# POST-INSTALLED ANCHORS REPORT

**Report Number:** 02191565.0054  
**Service Date:** 08/04/20  
**Report Date:** 08/05/20  
**Task:** 19 - Wood Framing Observation

DCI - Lee's Summit  
2001 Shamrock Rd  
Lee's Summit, MO

DCI - Lee's Summit	Site Plan:	Post-Installed Anchors Diagram	
	Report Number:	02191565.0054	
2001 Shamrock Rd	Technician:	Ethan Peck	15620 W 113th St
Lee's Summit, MO	Date:	08/04/20	Lenexa, KS 66219-5102
	Scale:	Not to Scale	913-492-7777

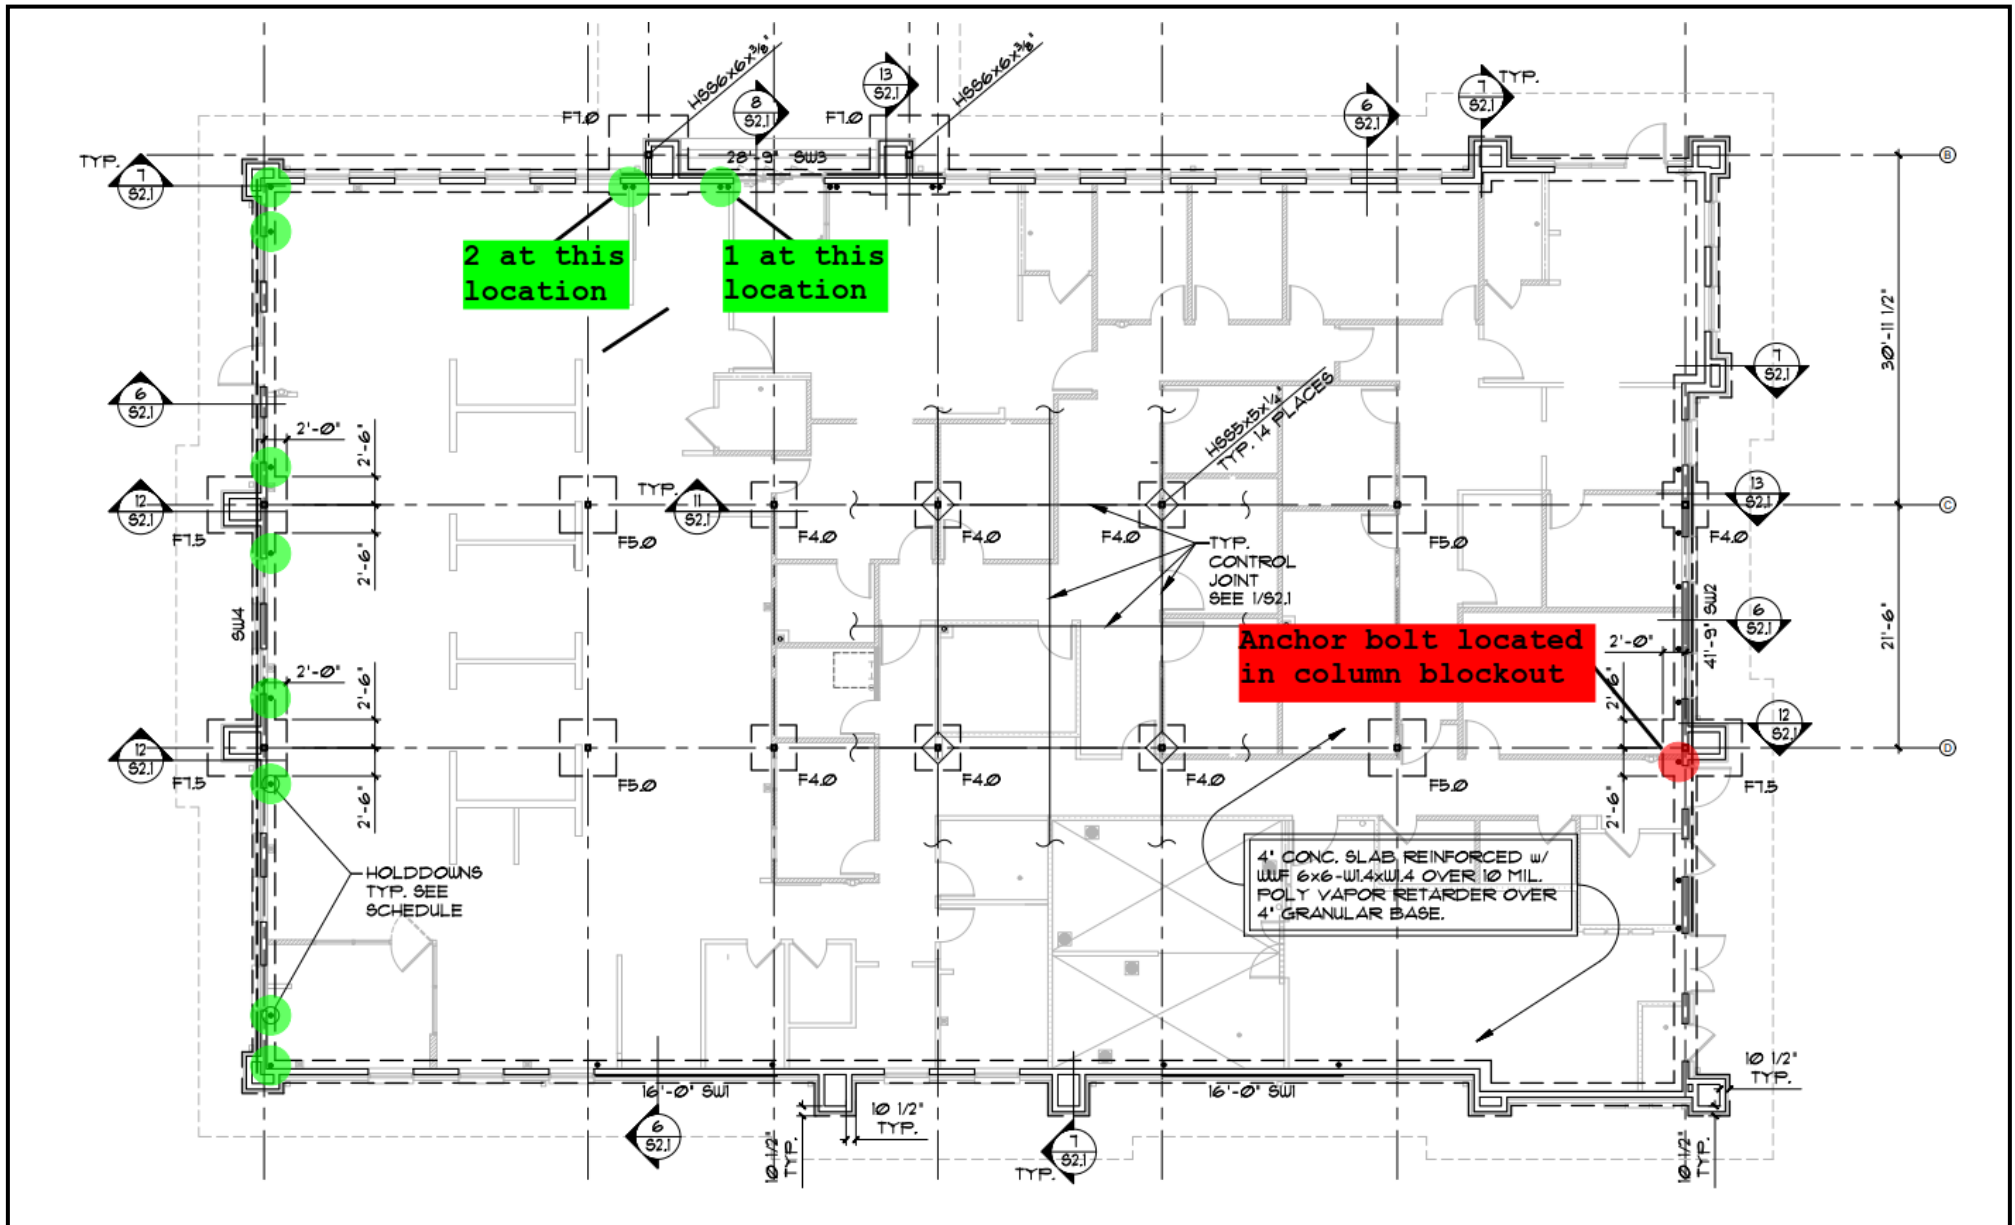
- 1) The contractor informed Terracon that an email from the structural engineer contained specifications for the post-installed anchor bolts. The email was not provided at the time of today's visit. Terracon is unable to verify if the anchor bolts were installed according to the structural engineer's specifications.
- 2) The shearwall holddown just west of gridline D/9 was not installed due to its location in the column blackout.
